Generic Environmental Impact Statement for License Renewal of Nuclear Plants

Supplement 24

**Regarding
Nine Mile Point Nuclear Station, Units 1 and 2**

Final Report

Figure 2-3. Nine Mile Point Site Layout

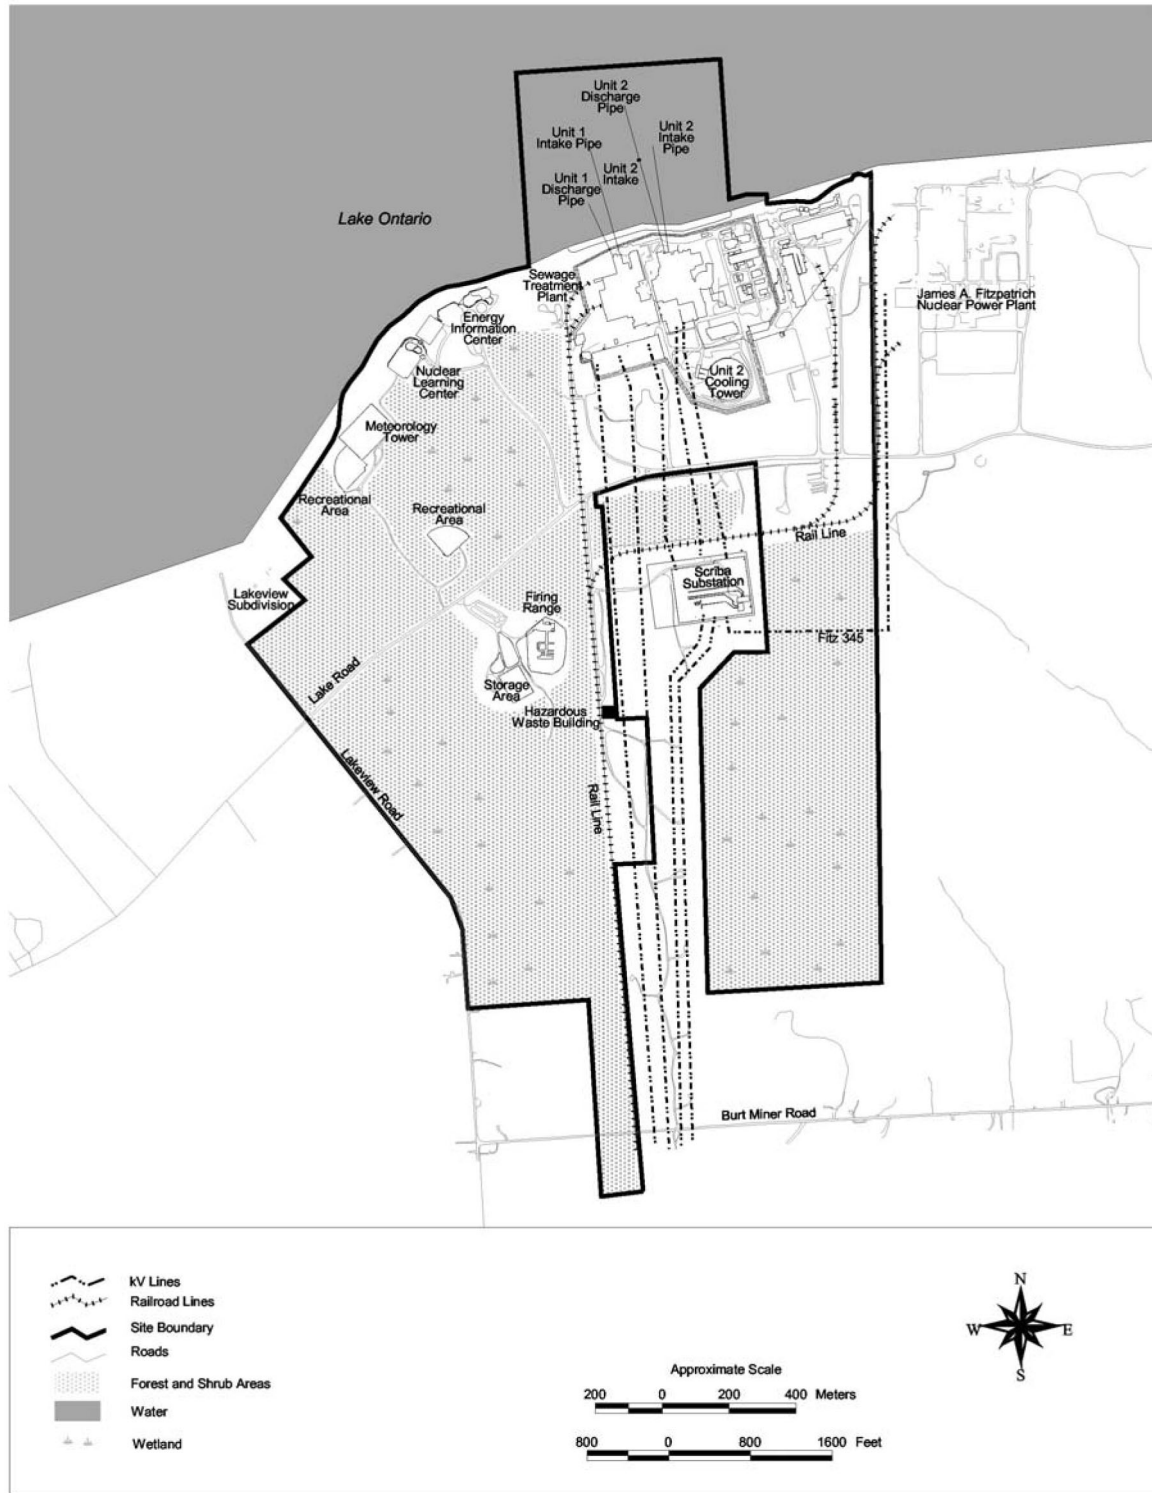
Comment: Page 8-8, Line 8. Mention is made of the "Lakeview Subdivision immediately west" of NMP (also shown in Figure 2-3). This area is now occupied by the Ontario Bible Conference Camp, which is mentioned on page 2-1, Line 23 and shown in Figure 2-2 of the DSEIS. NRC may wish to revise this sentence to clarify this point. (NMS-H-41)

Figure 2-4. Nine Mile Point Building Layout

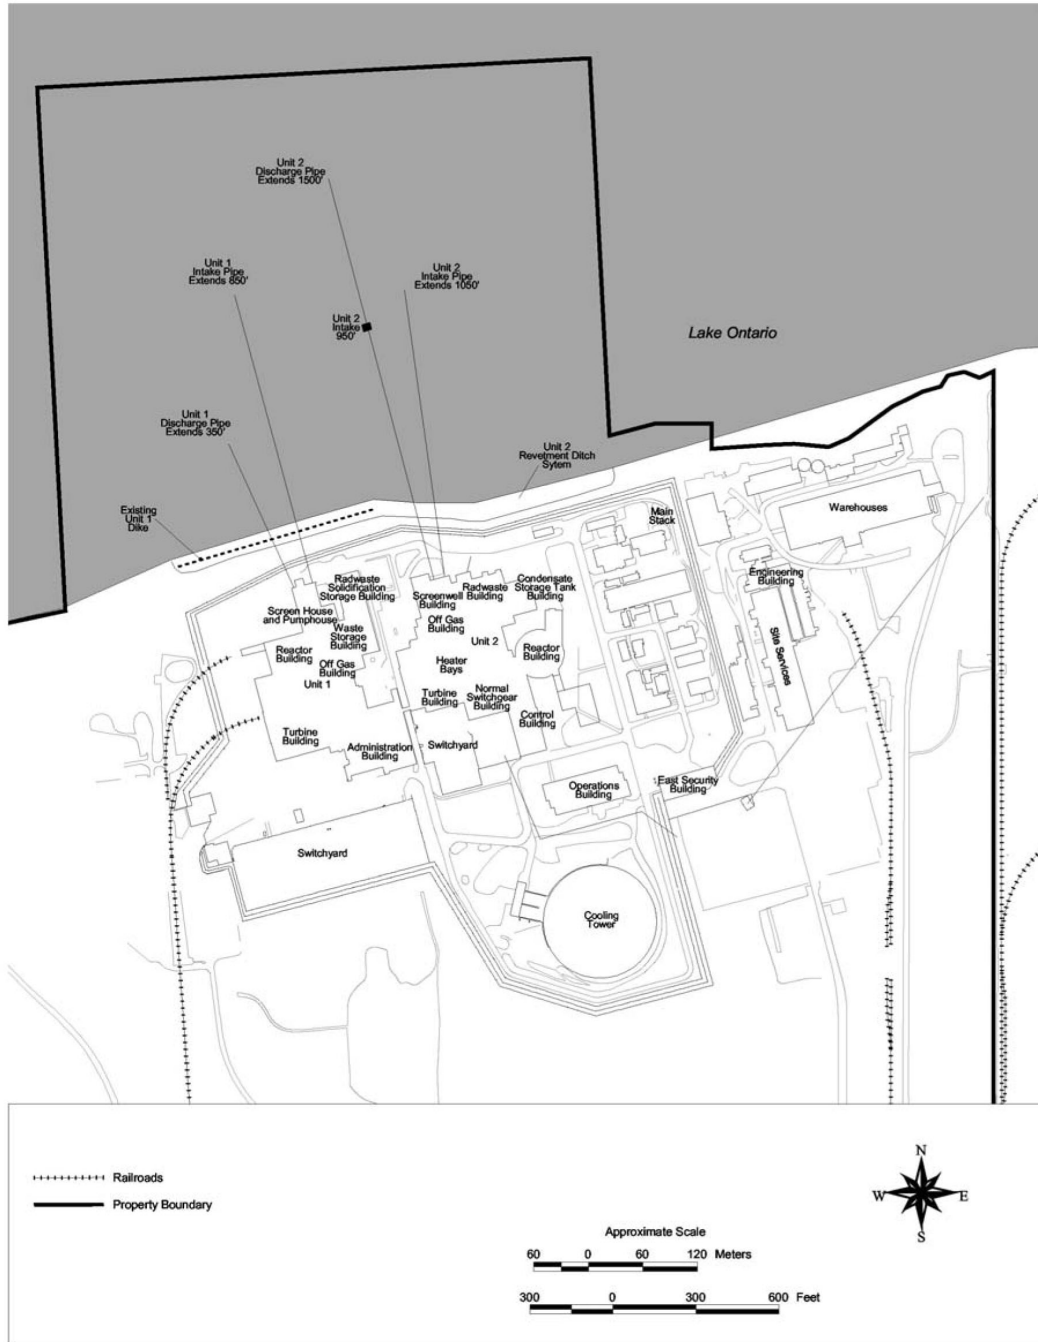
NMS-G-6 It may be appropriate to do periodic water-quality analyses of the discharge from the dewatering activity to ensure that pumping of the groundwater does not draw contaminated water from the petroleum contaminant plume. This may not be necessary if the text included technical discussion as to the fate and transport of the petroleum contaminant plume. The discussion should include information about whether the cone of depression has reached equilibrium or is still expanding; and distance from the former vehicle maintenance area to the dewatering pumps. (Figure 2-4 on page 2-6 is too blurry to determine this information).

Figure 4-1. Geographic Distribution of Minority Populations (Shown in Shaded Areas) Within 80 km (50 mi) of Nine Mile Point Units 1 and 2 Based on Census Block Group Data

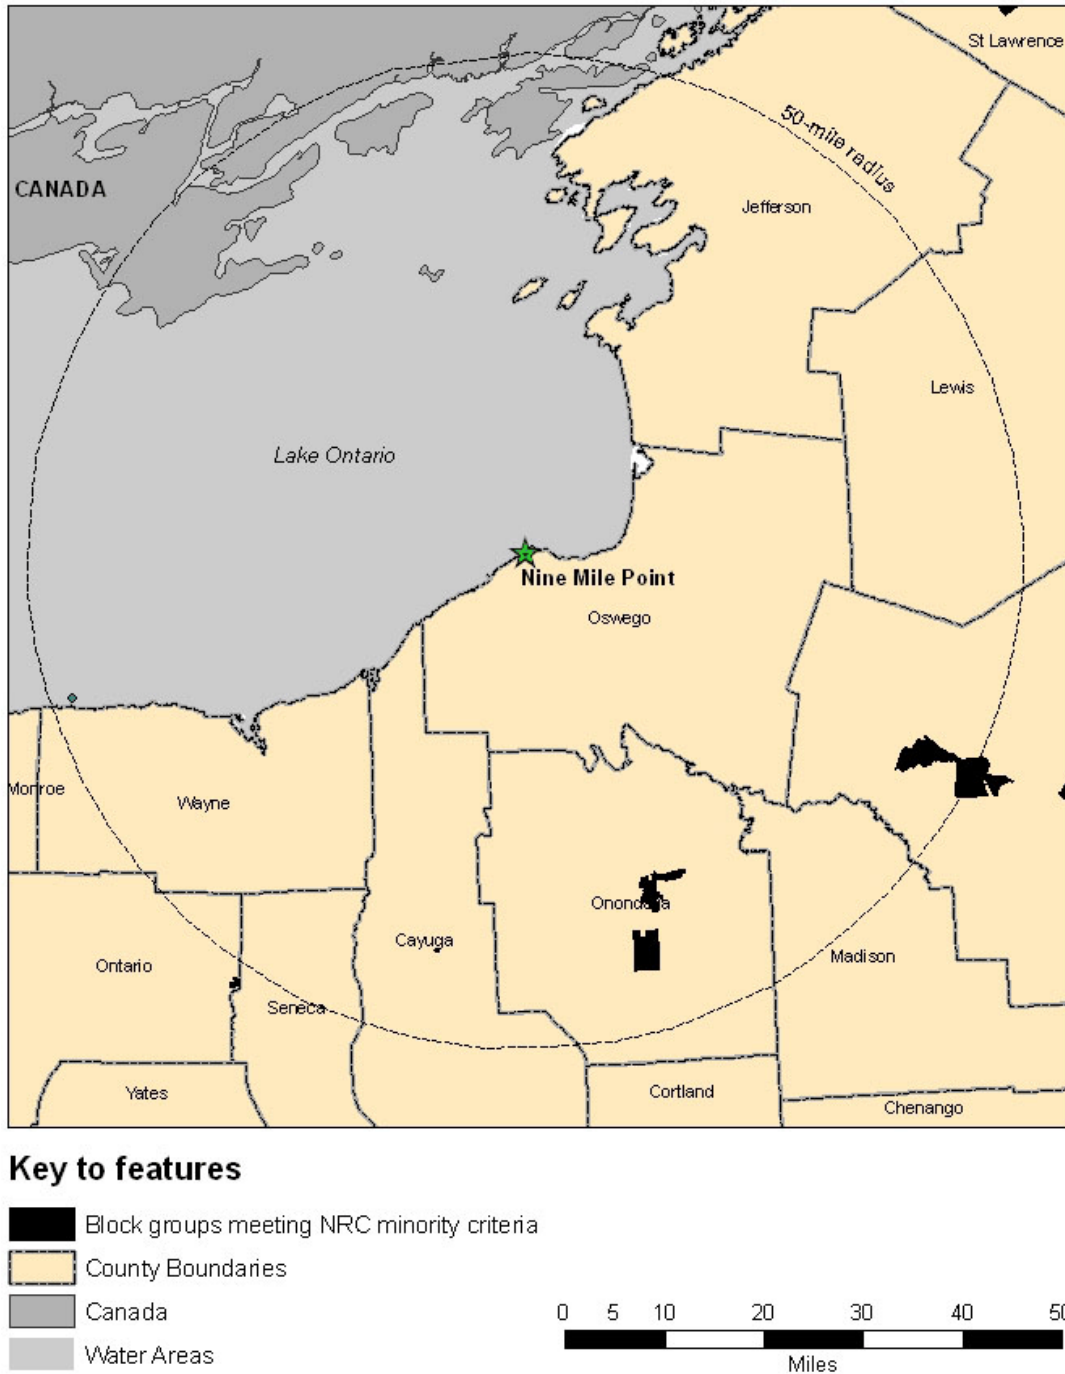
Comment: Page 4-37. Figure 4-1. Shaded areas on Figure 4-1 do not appear to correspond to areas noted in text of page 4-38 as having minority populations. No minority populations were identified in Oswego or Seneca Counties in the text and there are some depicted on the figure. Jefferson County is noted as having minority populations, yet none are apparent on the figure. The minority populations depicted on the figure in Cayuga County do not appear to correspond to those in the cited reference NMPNS 2004b. (NMS-H-39)

Response: *The comment is noted, figure 4-1 and the text in the SEIS have been modified to more clearly depict the information provided in reference NRC 2006.*

Figure 4-2. Geographic Distribution of Low-Income Populations (Shown in Shaded Areas) Within 80 km (50 mi) of Nine Mile Point Units 1 and 2 Based on Census Block Group Data

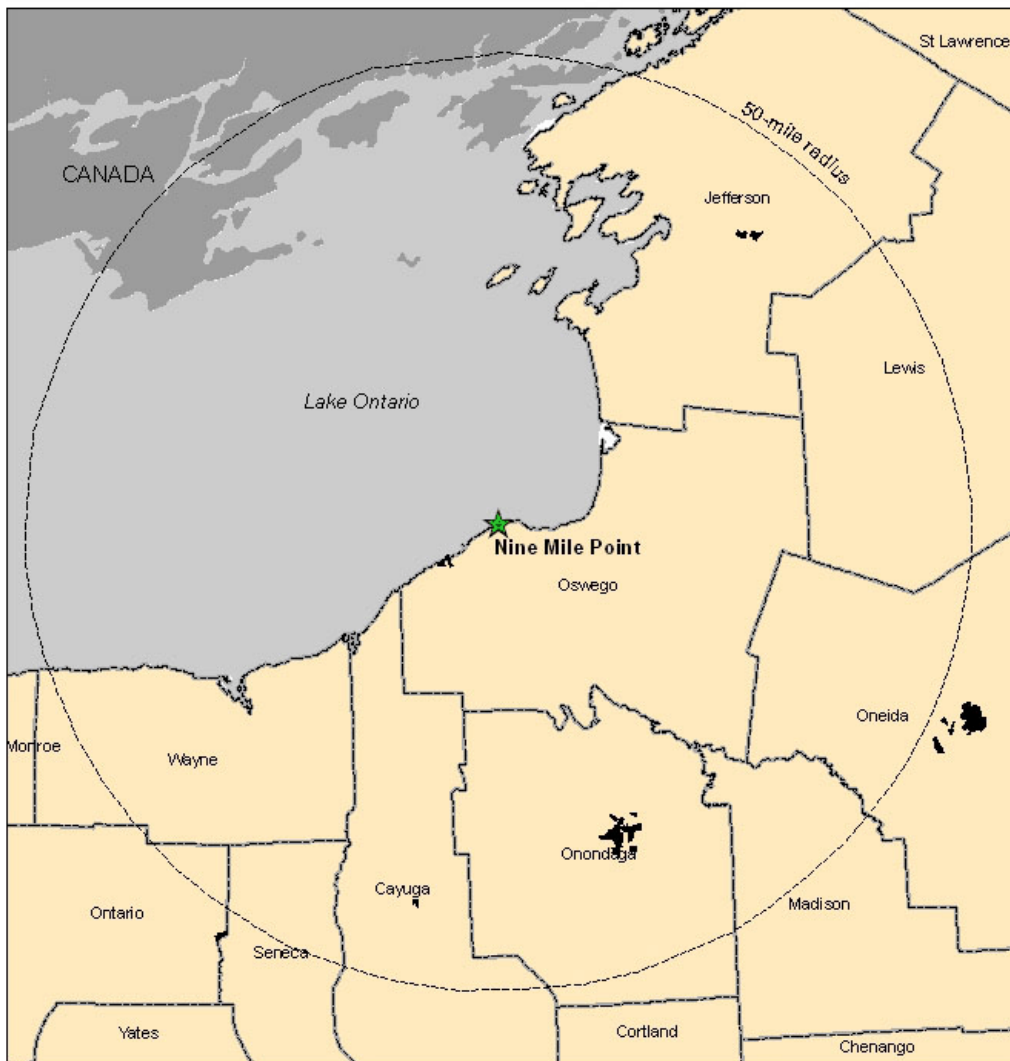
Comment: Page 4-39, Figure 4-2. Shaded areas on Figure 4-2 do not appear to correspond to areas noted in text on page 4-38 as having low-income populations. The low-income populations depicted on the figure in Cayuga, Oswego, Oneida, and Jefferson Counties do not appear to correspond to those in the cited reference NMPNS 2004b. (NMS-H-40)

Response: *Figure 4-2 has been modified in response to comment.*
